# CITY OF ALBUQUERQUE

**RE: 13301 La Arista Place NE**  
**Grading and Drainage Plan**  
**Engineer's Stamp Date: 03/11/22**  
**Hydrology File: F23D010E**

Re: Lot 9A Wilderness Estates (13301 La Arista)  
Review of the Lot Specific Grading and Drainage

SKLAR (MIKE CABBER, DESIGNER) - GRADING & DRAINAGE PLAN

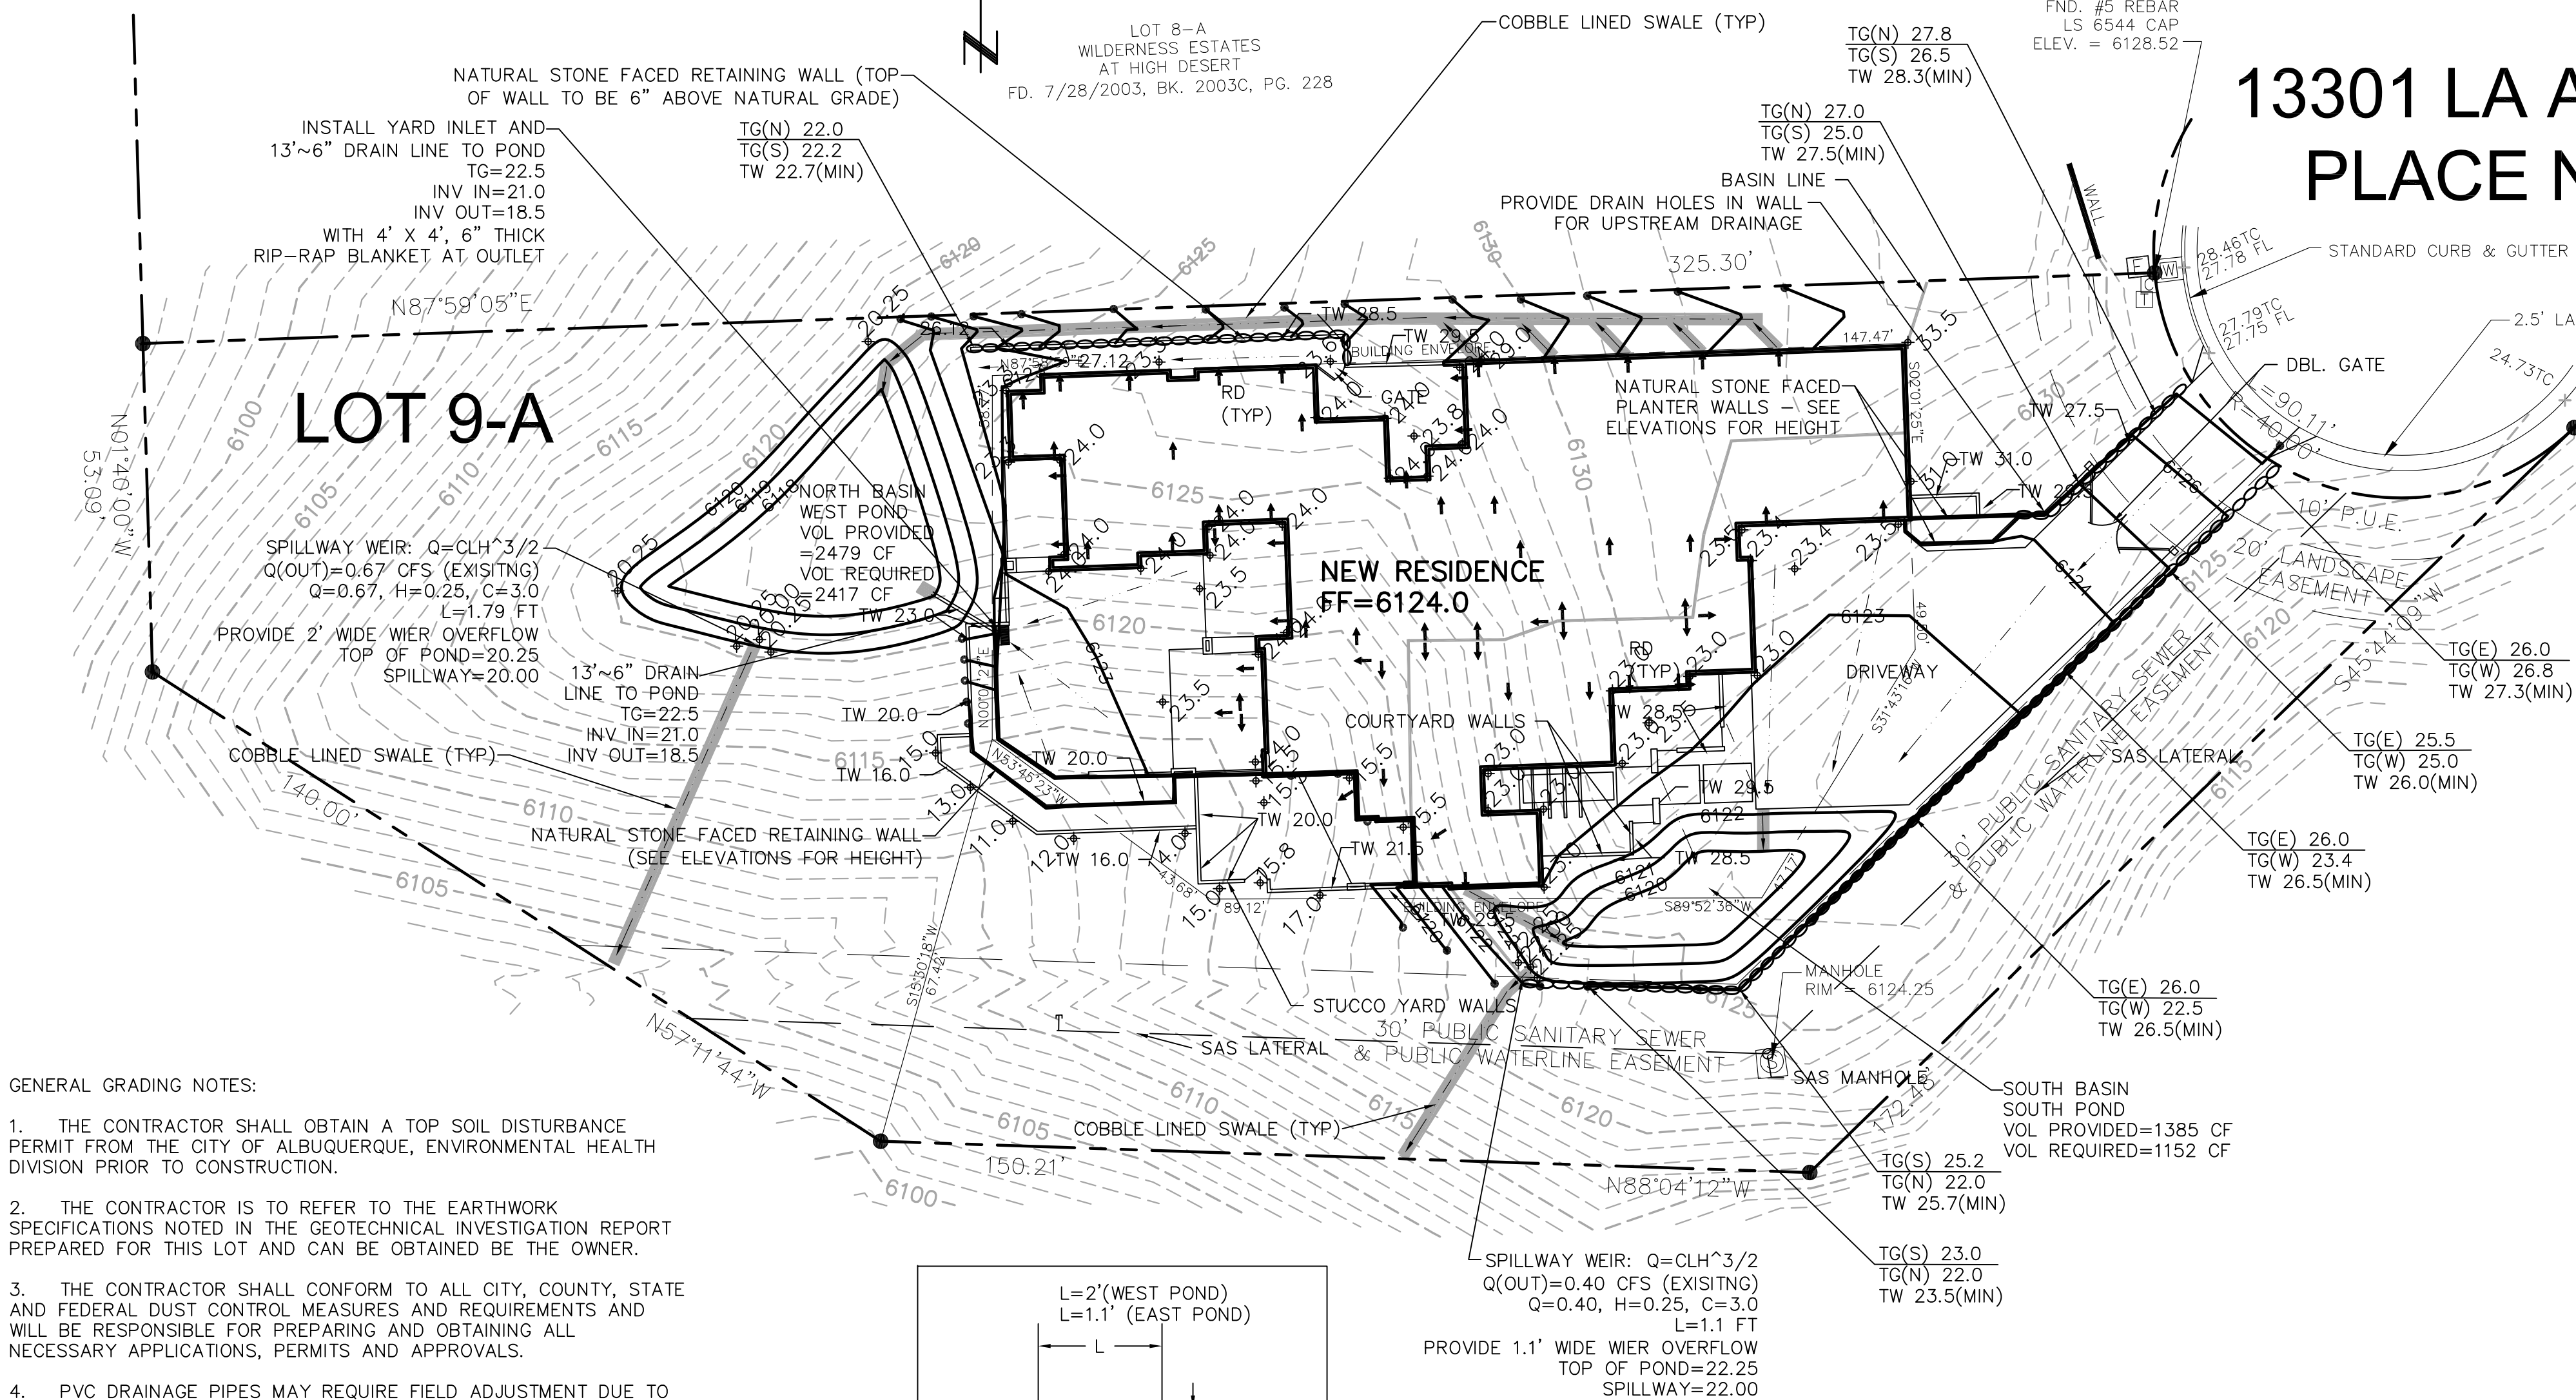
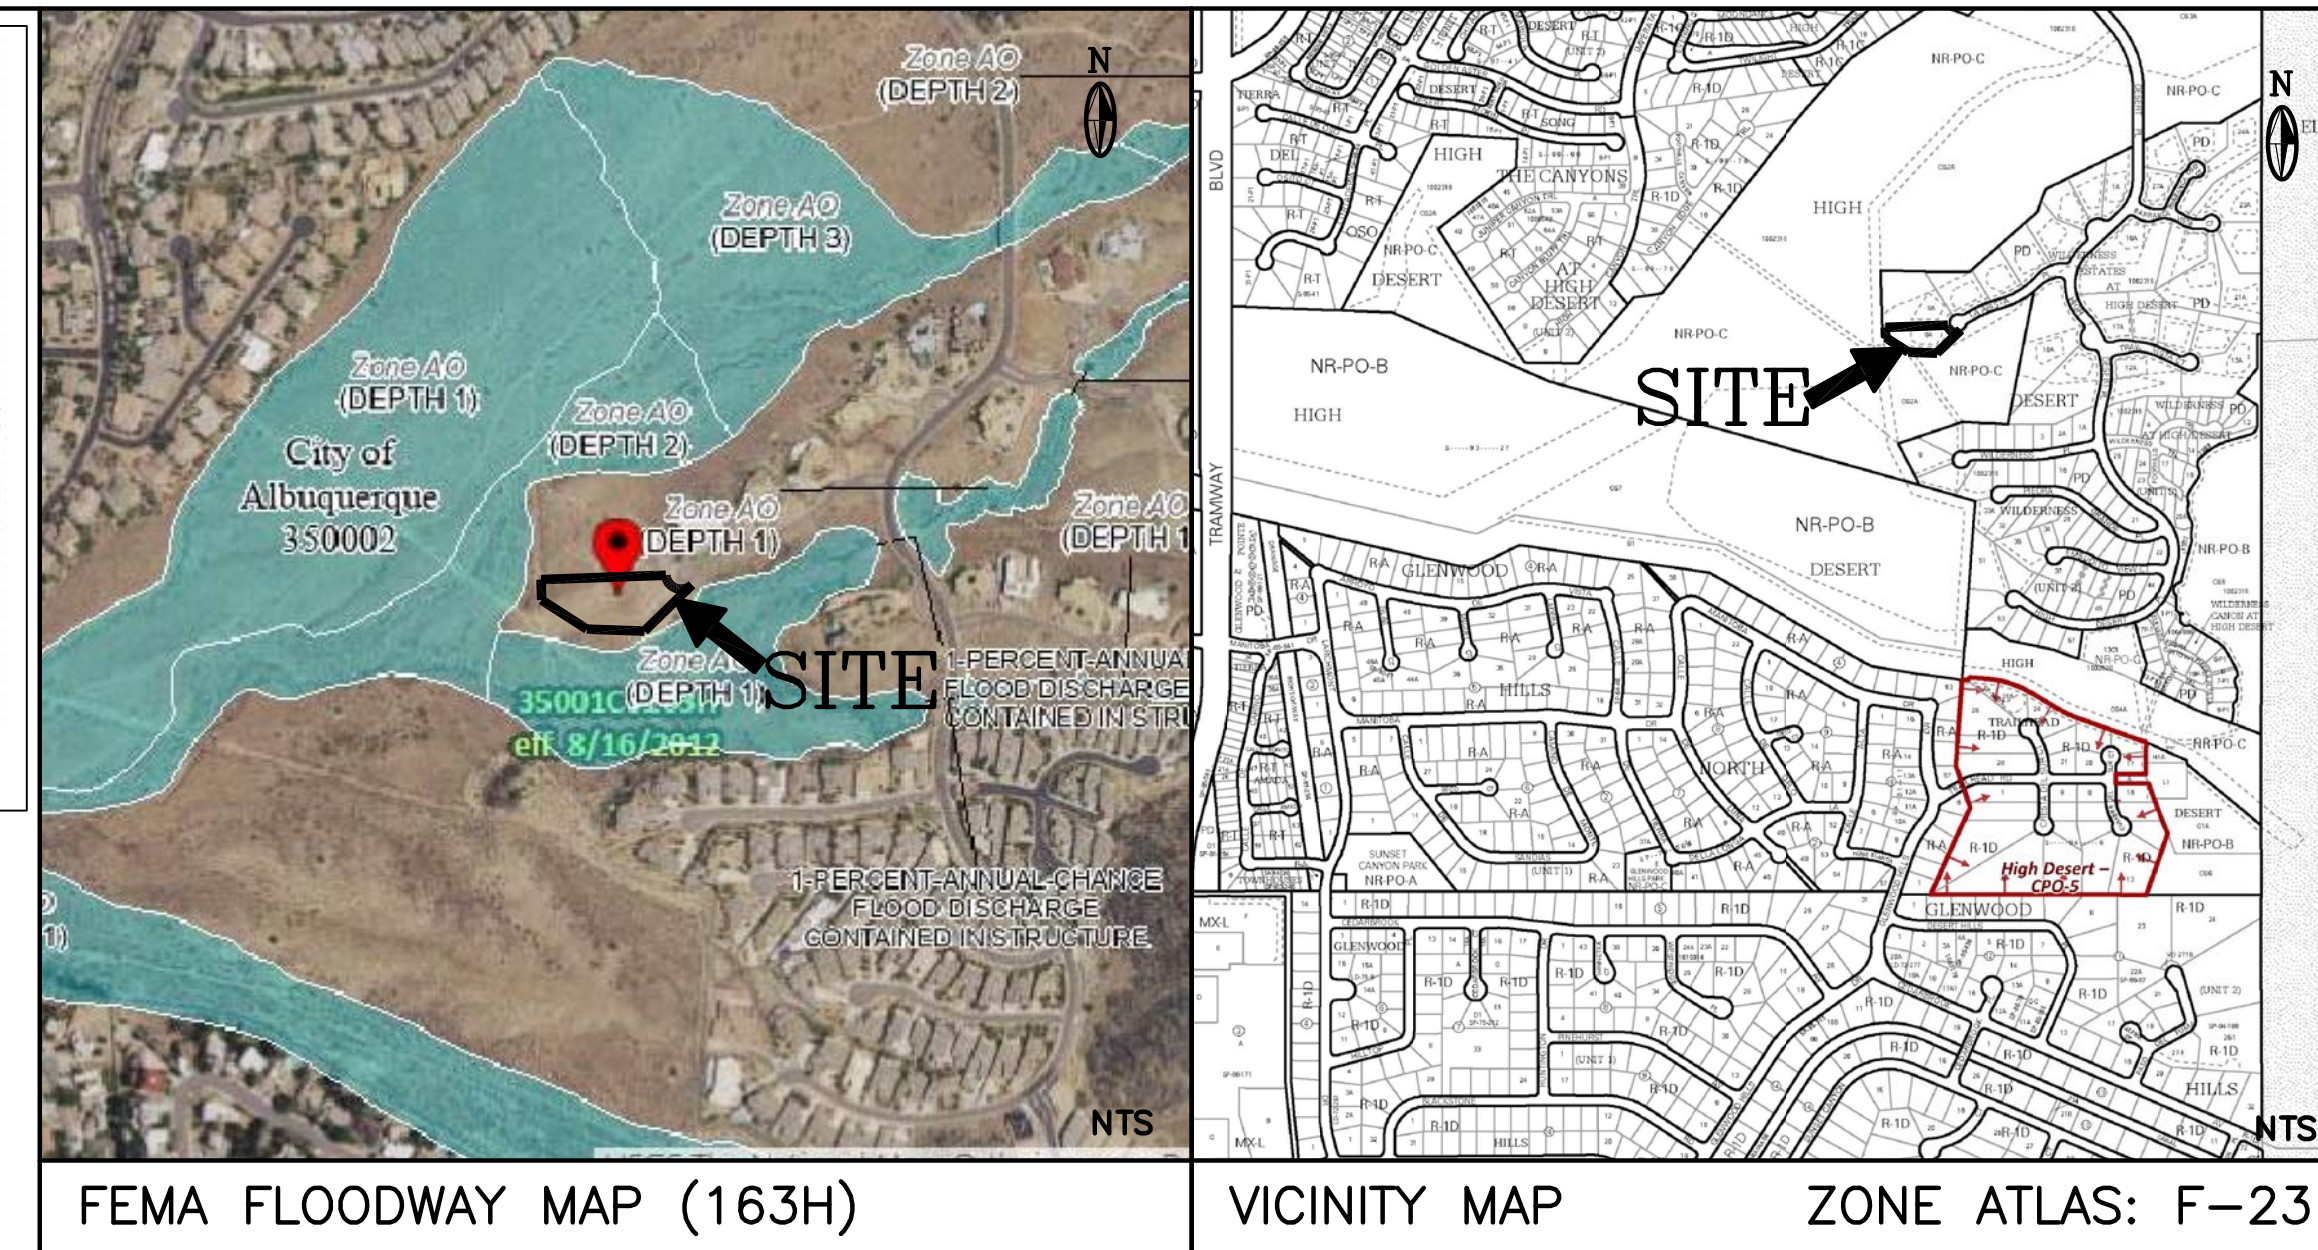
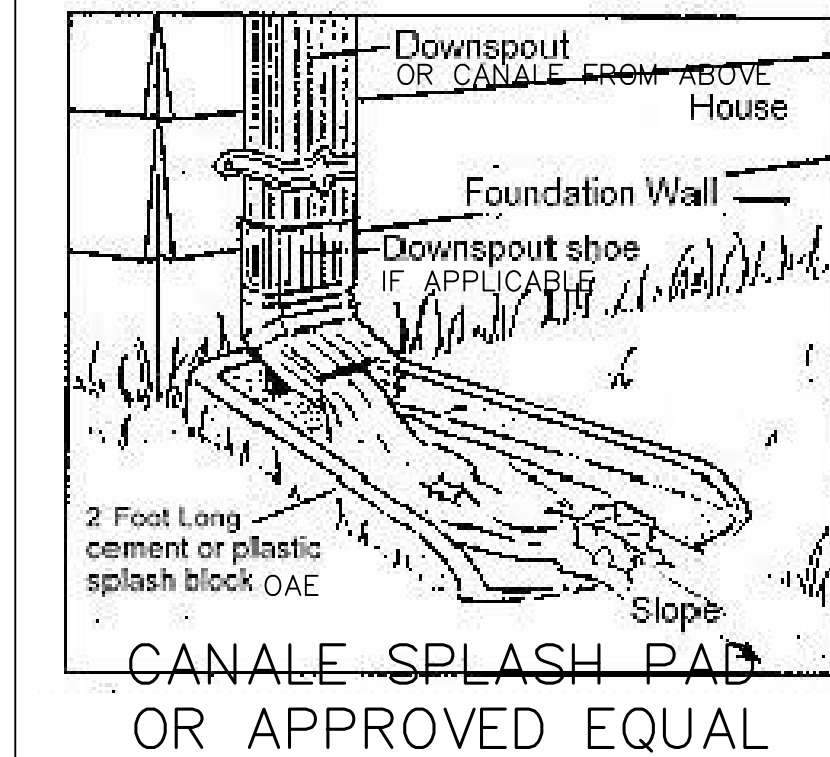
Based upon the information provided in your submittal received 03/22/2022, the Grading & Drainage Plan is approved for Grading Permit (earthwork can get started for the earth pad on the house).

1. Once the grading is complete, a pad certification (meaning that the earthwork is complete) will be required. Please include a site photo with the submittal. Also, at the time of pad certification approval, Hydrology will concurrently approve the Grading & Drainage Plan for Building Permit.
